TO: City Plan Board

FROM: Planning & Development Services Department
 Staff

DATE: Feb. 19, 2013

SUBJECT: Petition PB-12-150 PDV. Causseaux, Hewett and Walpole, Inc., agent for S. Clark Butler Properties Corp. et al, and Robert Doan and Roy Lambert Jr., agents for Regency Windmeadows Limited Partnership. Planned Development zoning for a mixed use/commercial development. Zoned: PD (Planned Development District), BI (Business Industrial district), and BUS (General Business District). Located between SW Archer Road and SW 24th Avenue, and between SW 40th Blvd. and SW 34th Street. Related to PB-12-148 CPA & PB-12-149 LUC.

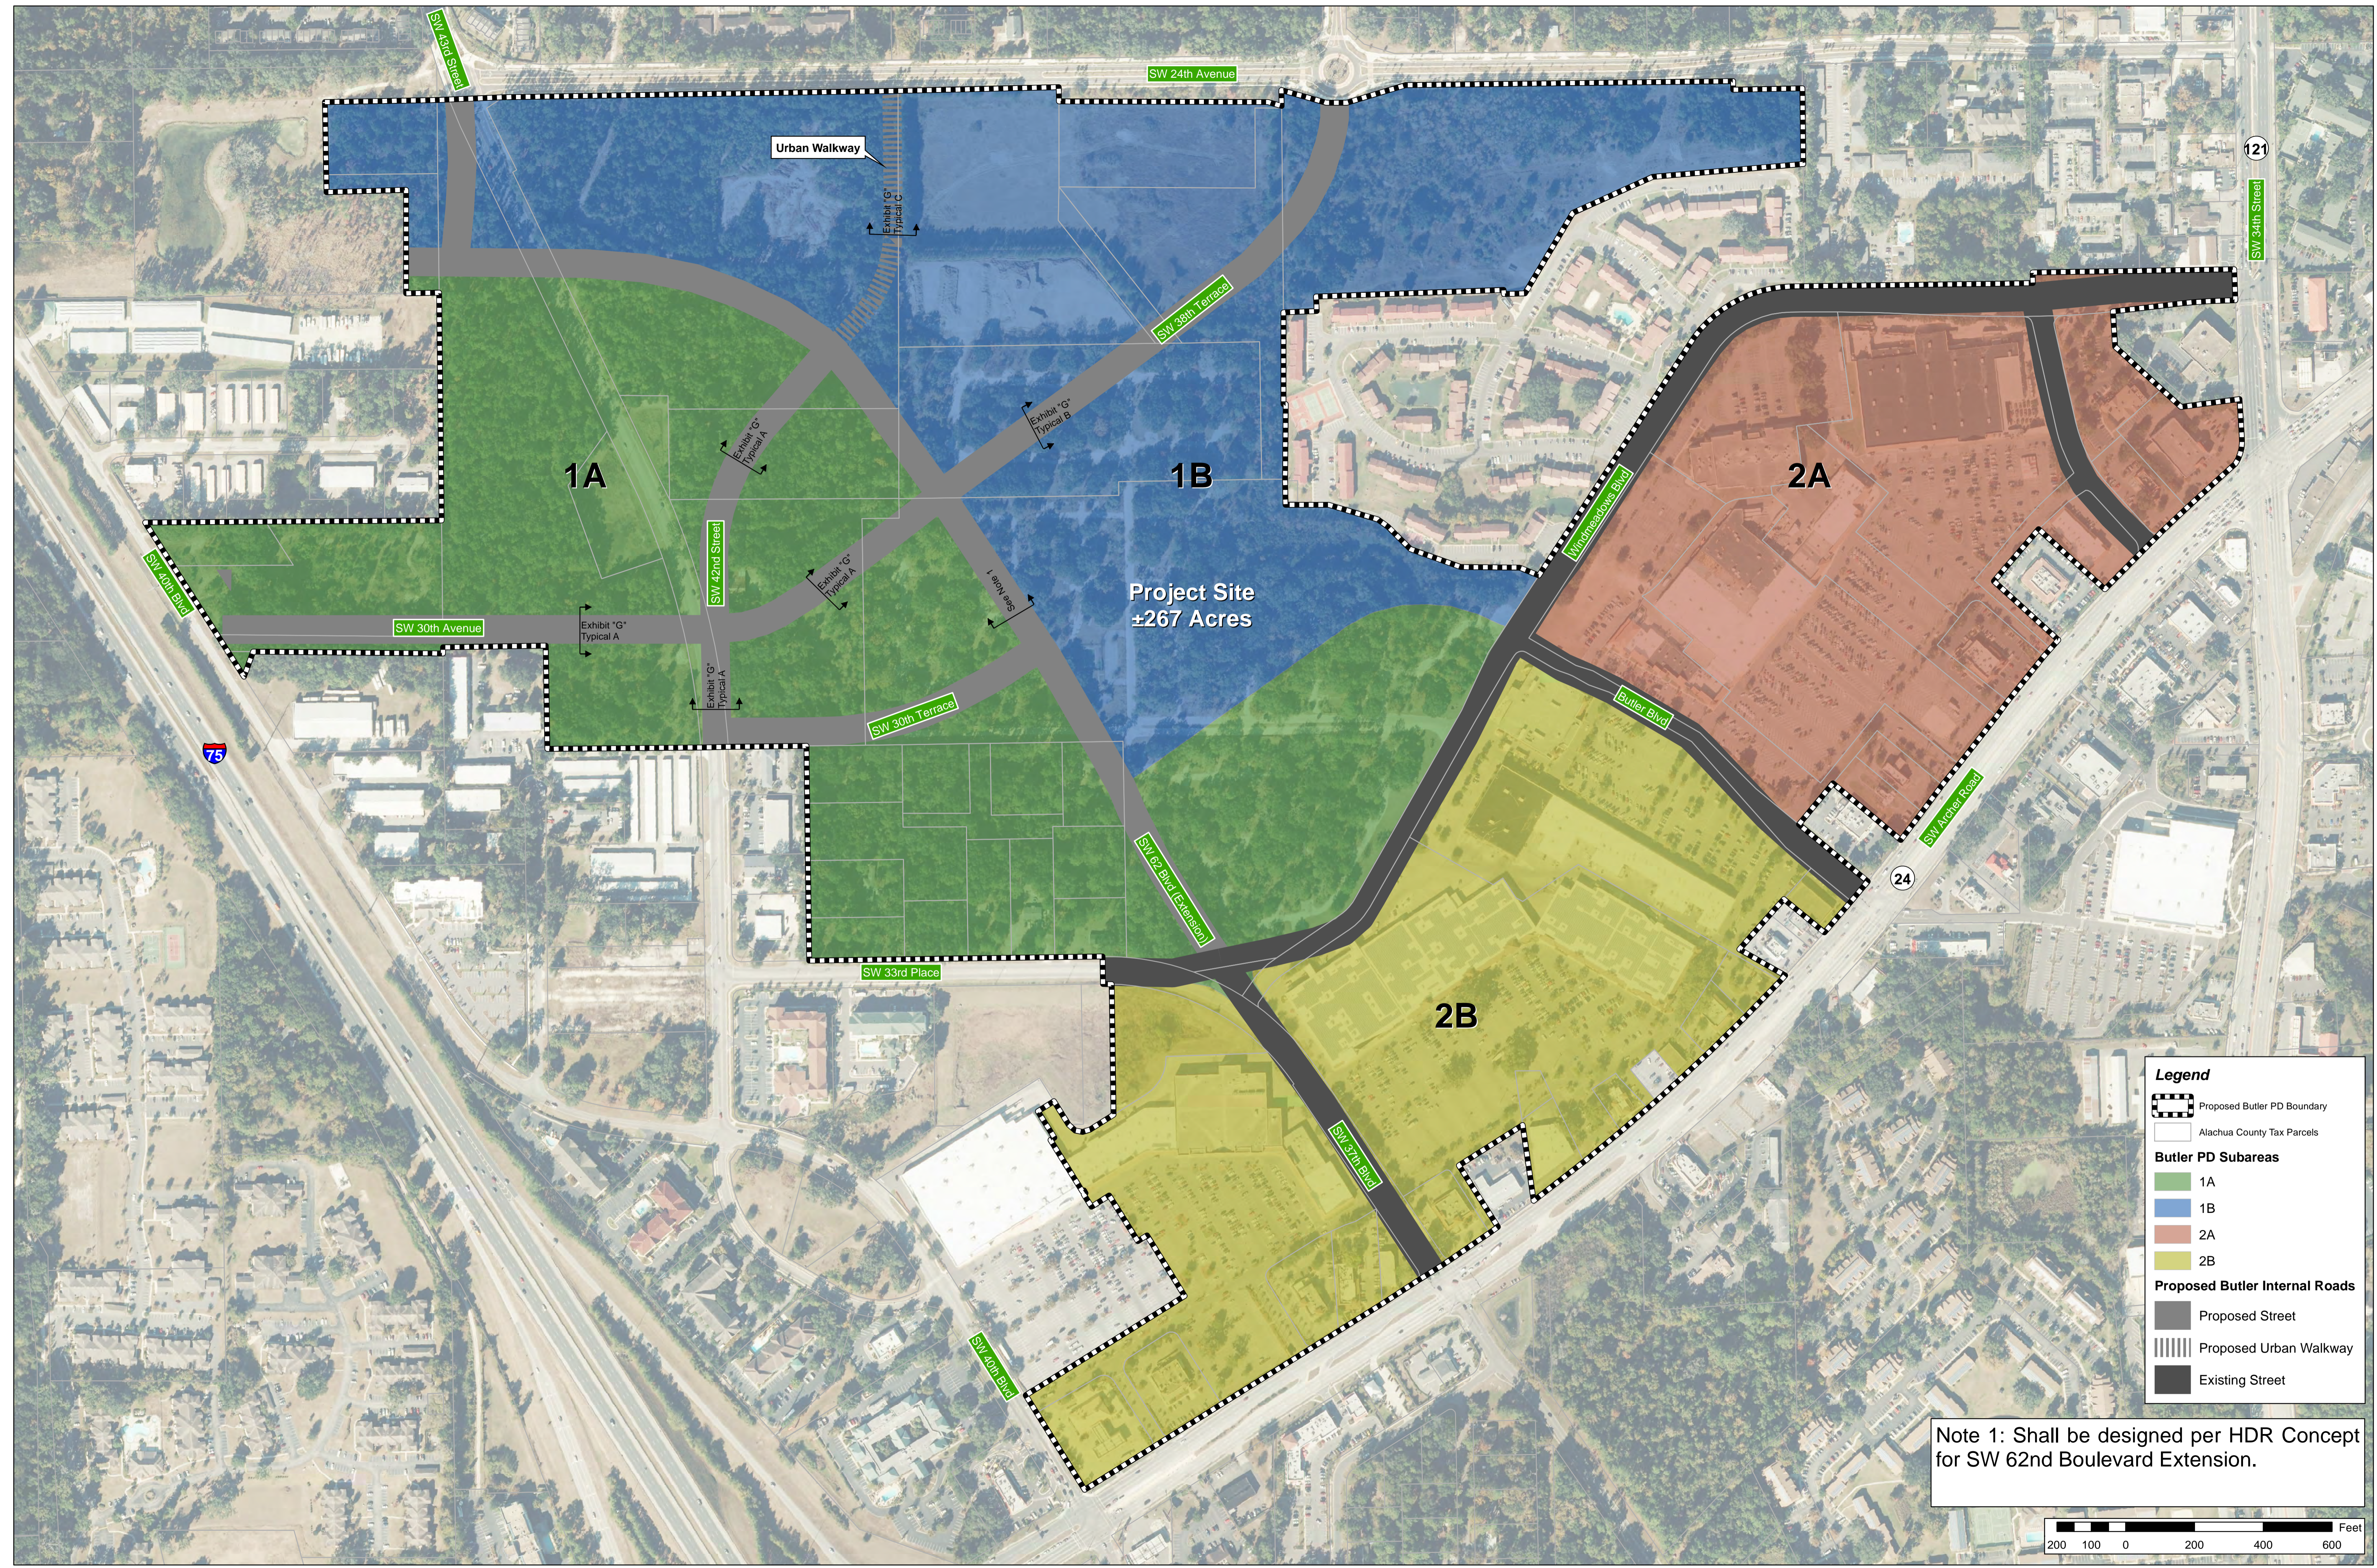
PD Layout Map and Public Streets – Staff is recommending that the PD Layout Map show the general location of the transit transfer station and the Archer Braid Trail, since these are important features of the PD and their location may affect the planning and design of adjacent development and infrastructure. The PD Layout Map should also identify cross sections for SW 30th Terrace and the portion of SW 43rd Street that will be reconstructed. Consideration should be given to further enhancing the street network shown on the map with additional public street connections. For example, SW 43rd Street could be extended southward to SW 30th Avenue, and Butler Boulevard could be extended north to connect to SW 38th Terrace. The revised Butler Planned Development (PD) proposes an 'urban walkway' in Subarea 1B. This Urban Walkway replaces the

Private Street Grid – The proposed PD Layout Map does not show the network of private streets and drives that will serve the proposed development and provide an additional layer of connectivity below the larger public street network. Staff recognizes that it is difficult to determine the best location for these streets at this time, without knowing the future parameters of development. However, the regulations for the PD do need to provide a maximum block perimeter for each of the subareas, and then clarify what types of private streets or drives will count toward meeting these perimeter requirements. The 2000 foot block perimeter proposed for Subareas 1B and 2A is satisfactory, but staff recommends a maximum 2000 foot block perimeter in Subarea 2B and an average 3200 foot block perimeter for Subarea 1A. The 3200 foot block perimeter is consistent with the absolute maximum allowed for in the Comprehensive Plan for development in the Urban Village area. These larger block sizes are more appropriate for the part of the development that is designed to provide destination retail uses that will directly serve a regional area. By comparison, the existing PD requires an average block size of 1600 feet everywhere except for the destination retail development in Subarea 2, and a maximum block size of 2000 feet in all subareas.

CLIENT:	BUTLER ENTERPRISES
PROJECT:	BUTLER PLAZA DEVELOPMENT PHASE I
DESIGNER:	C.L. STAPLER
QUALITY CONTROL:	R.J. WALPOLE, PE
PROJECT NUMBER:	A.S. ROBERTS, PE
SHEET TITLE:	TYPICAL CROSS SECTIONS
	12-0296

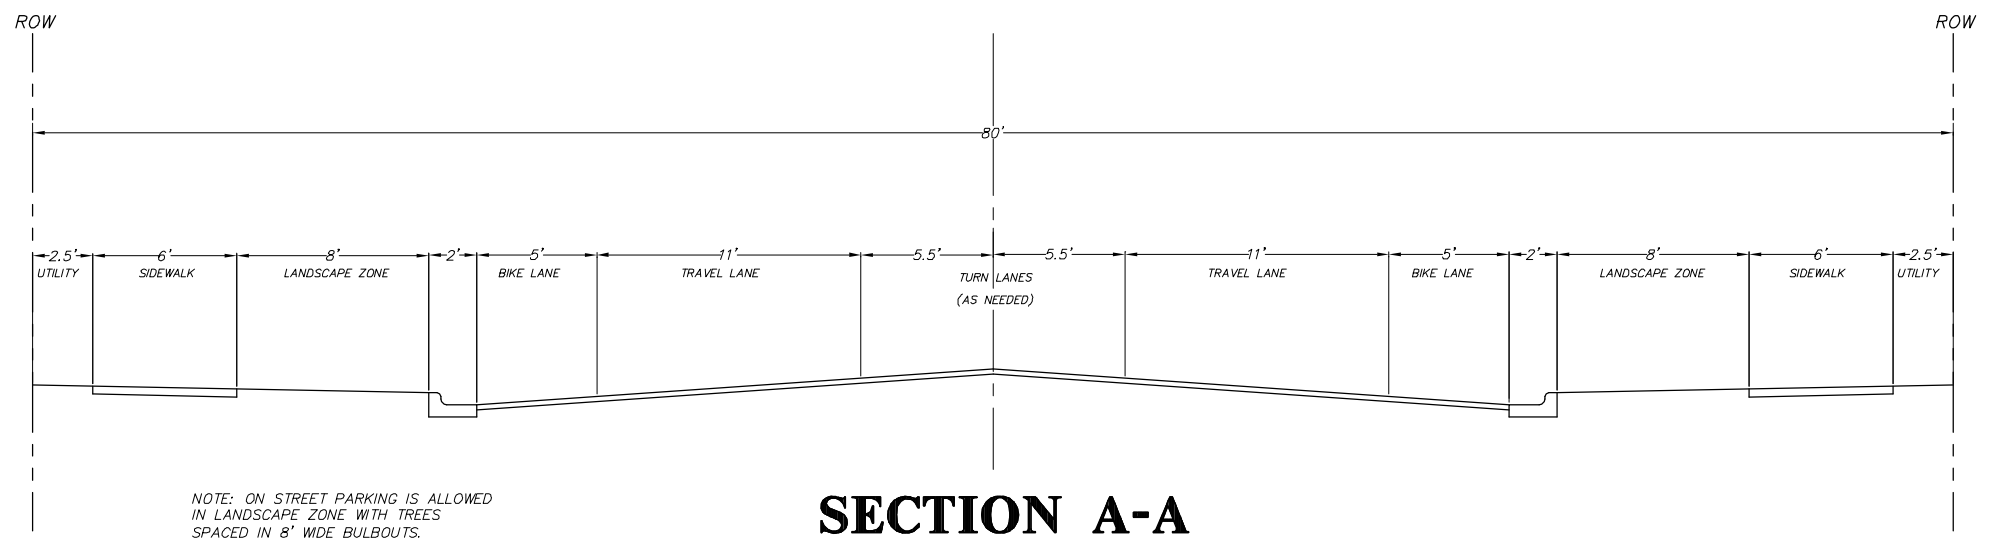
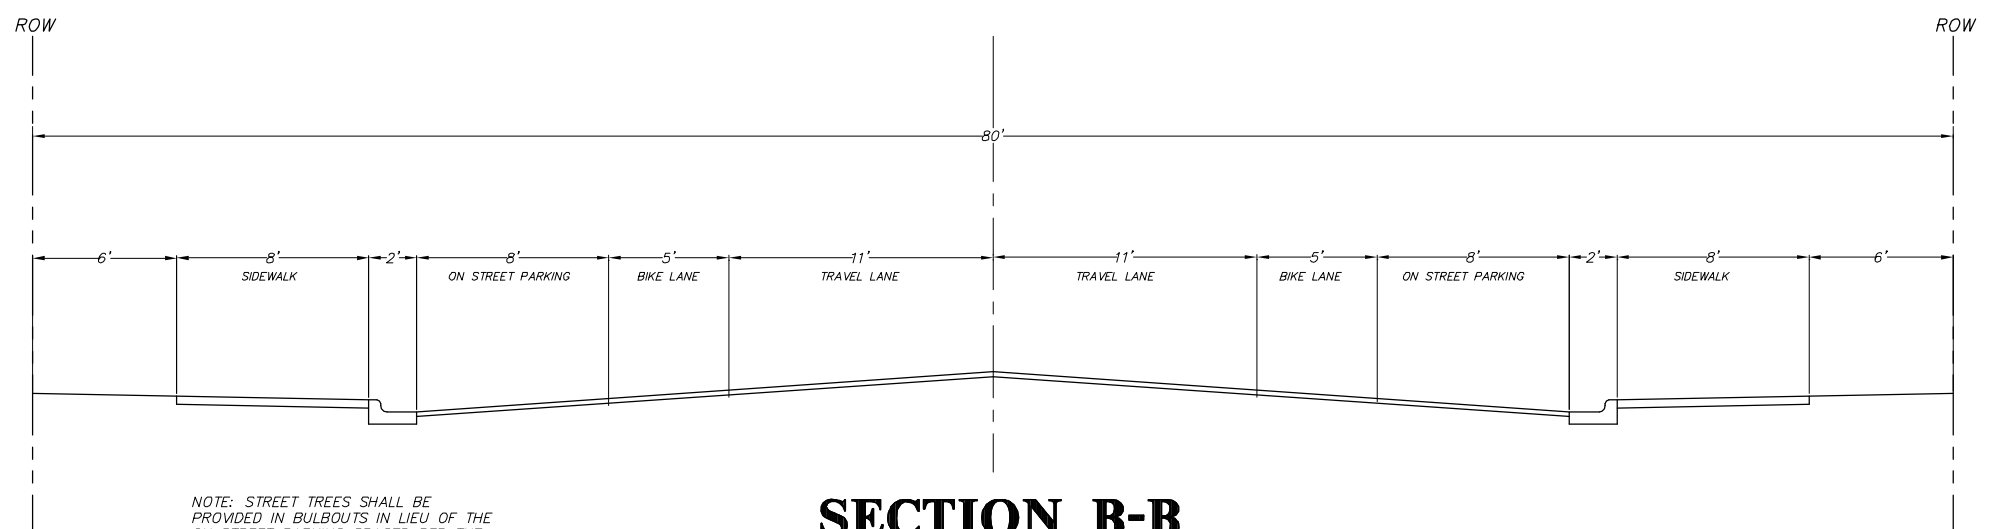
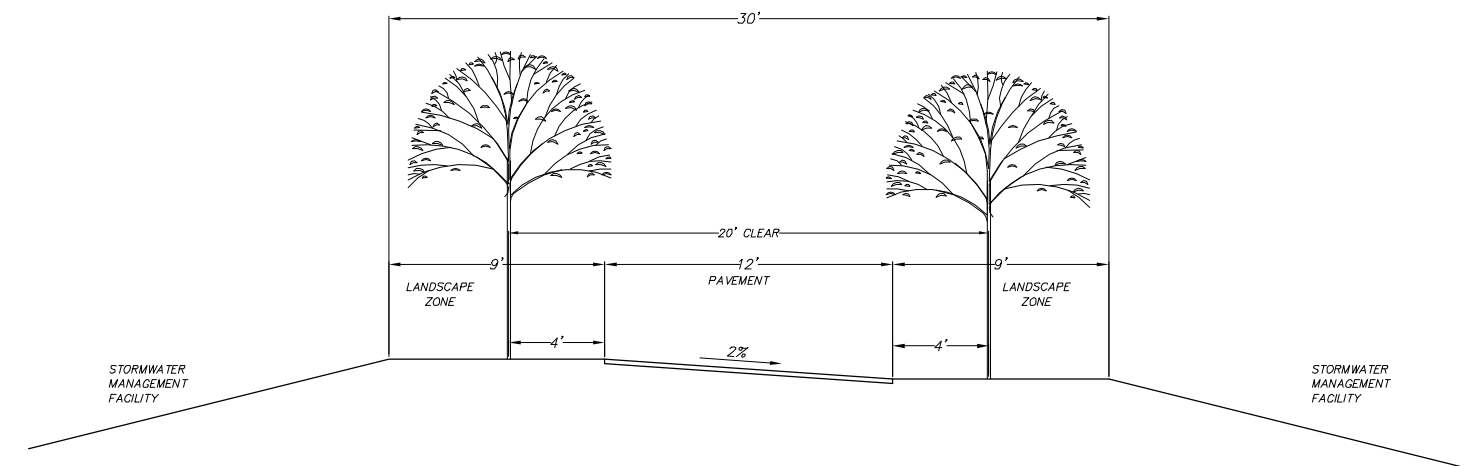
The cross sections shown for Typical A and B street types appear to meet the requirements for public streets. However, none of the cross sections show more than an 80-foot right-of-way, and the cross section for SW 30th Avenue should continue to reflect existing requirements to provide 90 feet of right-of-way. This width will allow for the Archer Braid Trail and some additional flexibility for a potential future vehicular connection to the adjacent interstate flyover. The flyover is being proposed as part of the Celebration Pointe development within Alachua County, and will contain four vehicular travel lanes, one dedicated transit lane, and the Archer Braid Trail. The current proposal for the flyover has it crossing the interstate just to the south of the Butler PD project boundary.
